ADDENDUM A

Staff Report: Z-16-18-5

Maryvale <u>Village Planning Committee</u>	May 9, 2018
Meeting Date:	
<u>Planning Commission</u> Hearing Date:	June 7, 2018
Request From:	<u>PUD PCD</u> (131.27 Acres)
Request To:	<u>R1-6</u> (131.27 Acres)
Proposed Use:	Single-Family Residential
Location:	Northeast corner of Loop 101/Agua Fria Freeway and Indian School Road
Owner/Applicant:	Algodón AG Revocable Land Trust
Representative:	Stephen W. Anderson, Gammage & Burnham, PLC
Staff Recommendation:	Approval, subject to stipulations

INDIAN SCHOOL AND 101

Circulation Plan

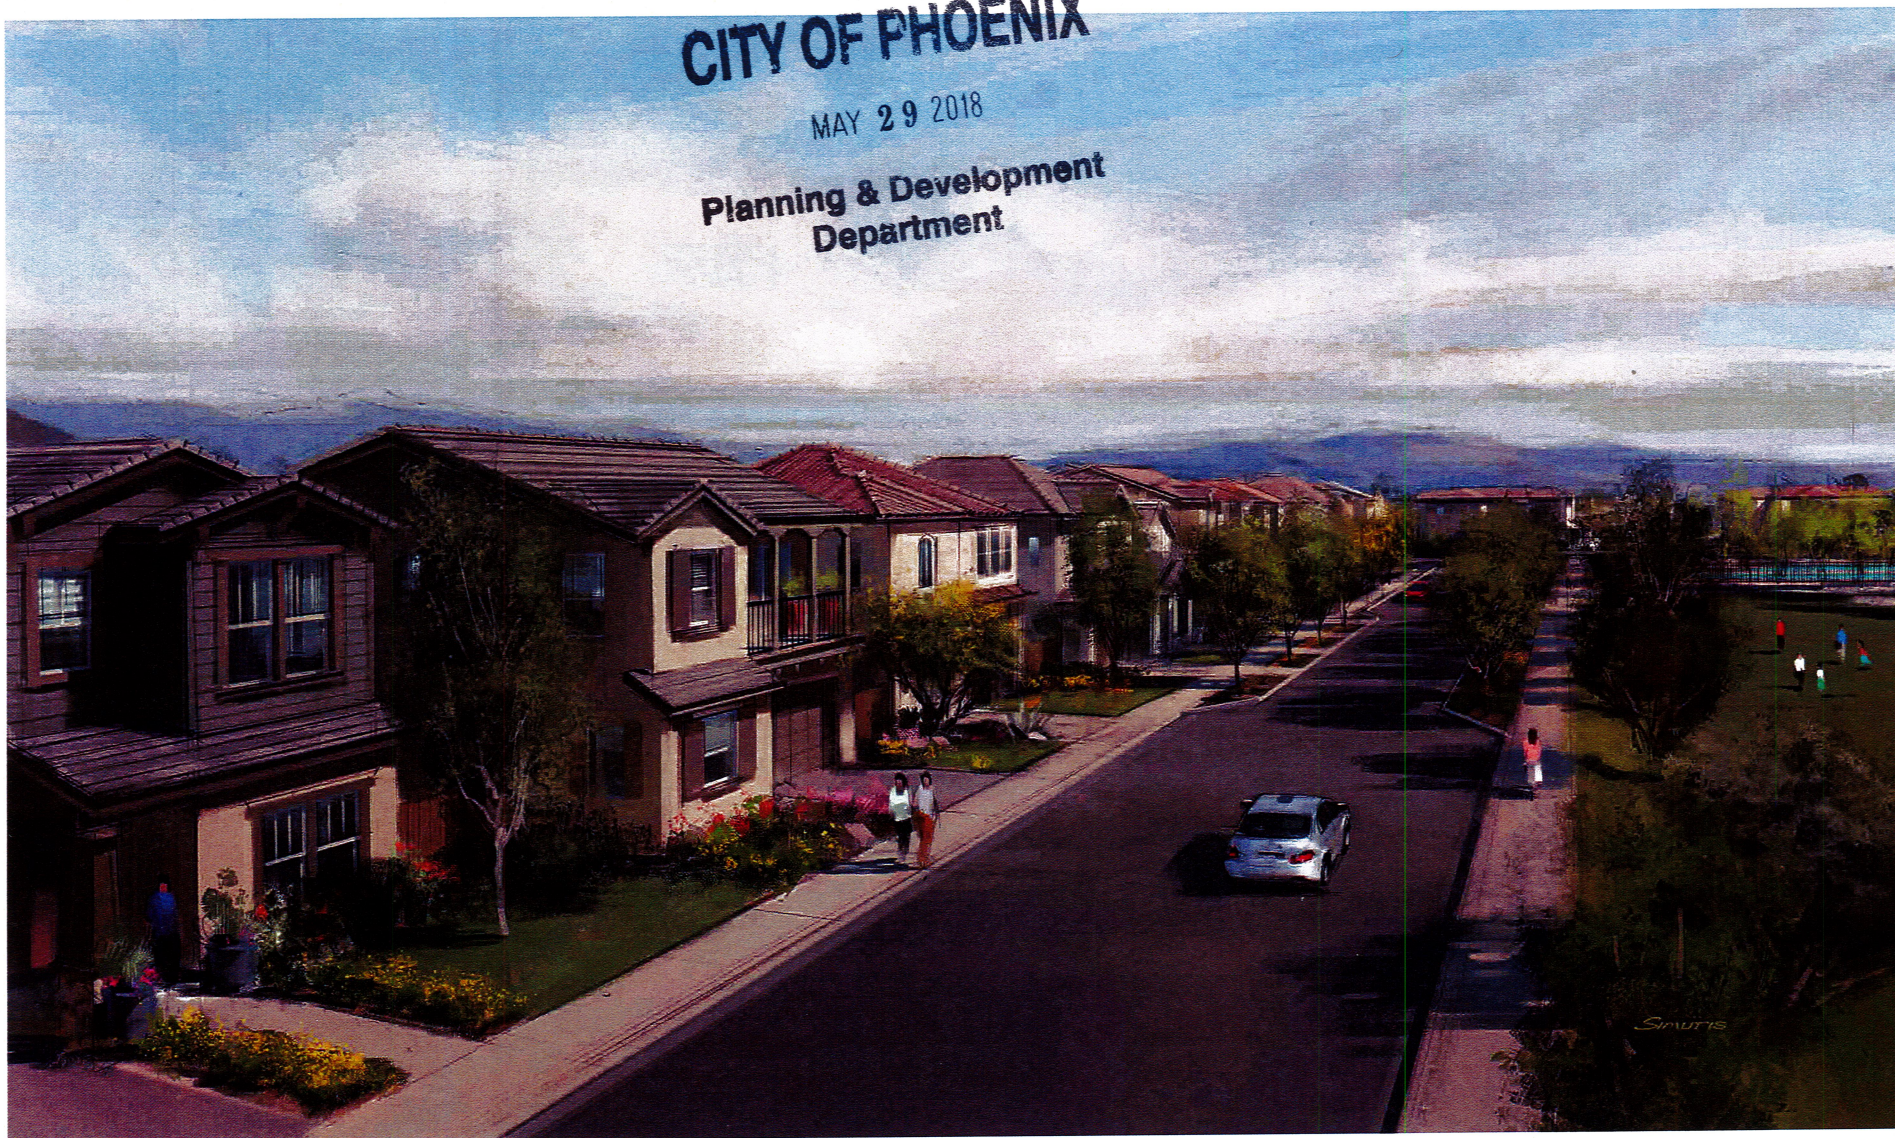
As a result of ongoing dialogue, and the applicant's submittal of a revised Circulation Plan, city staff and the applicant have come to an agreement to revise the following:

- Revise stipulation 2 to increase the minimum open space from 15% to 20%.
- Remove stipulation 4 which has been addressed through the depiction of a pedestrian pathway along the western boundary in the revised Circulation Plan.
- Modify stipulation 6 to stipulate general conformance to the quantity and location of circulation elements (sidewalks, trails, and traffic mitigation infrastructure) as depicted on the revised Circulation Plan.

THE DEVELOPMENT'S CIRCULATION ELEMENTS (SIDEWALKS, TRAILS, AND TRAFFIC MITIGATION INFRASTRUCTURE) SHALL BE IN GENERAL CONFORMANCE WITH THE CIRCULATION PLAN DATE STAMPED JUNE 4, 2018, AS APPROVED OR MODIFIED BY THE PLANNING AND DEVELOPMENT DEPARTMENT WITH SPECIFIC REGARD TO THE, SIZES, QUANTITIES AND LOCATIONS OF THE ELEMENTS AND THE INCLUSION OF THE FOLLOWING PROVISIONS.

- A. DETACHED SIDEWALKS SHALL INCLUDE A MINIMUM FIVE-FOOT-WIDE LANDSCAPED STRIP LOCATED BETWEEN THE SIDEWALK AND BACK OF CURB AND MINIMUM 2-INCH CALIPER SHADE TREES PLANTED A MINIMUM OF 20 FEET ON CENTER OR IN EQUIVALENT GROUPINGS ALONG BOTH SIDES OF THE SIDEWALK.
- B. EACH "DETACHED SIDEWALK CHOKER TRAFFIC CALMING" ELEMENT SHALL BE A MINIMUM LENGTH OF 60 FEET AND THE PLANNING AND DEVELOPMENT DEPARTMENT SHALL HAVE THE AUTHORITY TO REDUCE THE MINIMUM LENGTH TO ACCOMMODATE OTHER SITE CONSIDERATIONS UPON REQUEST.
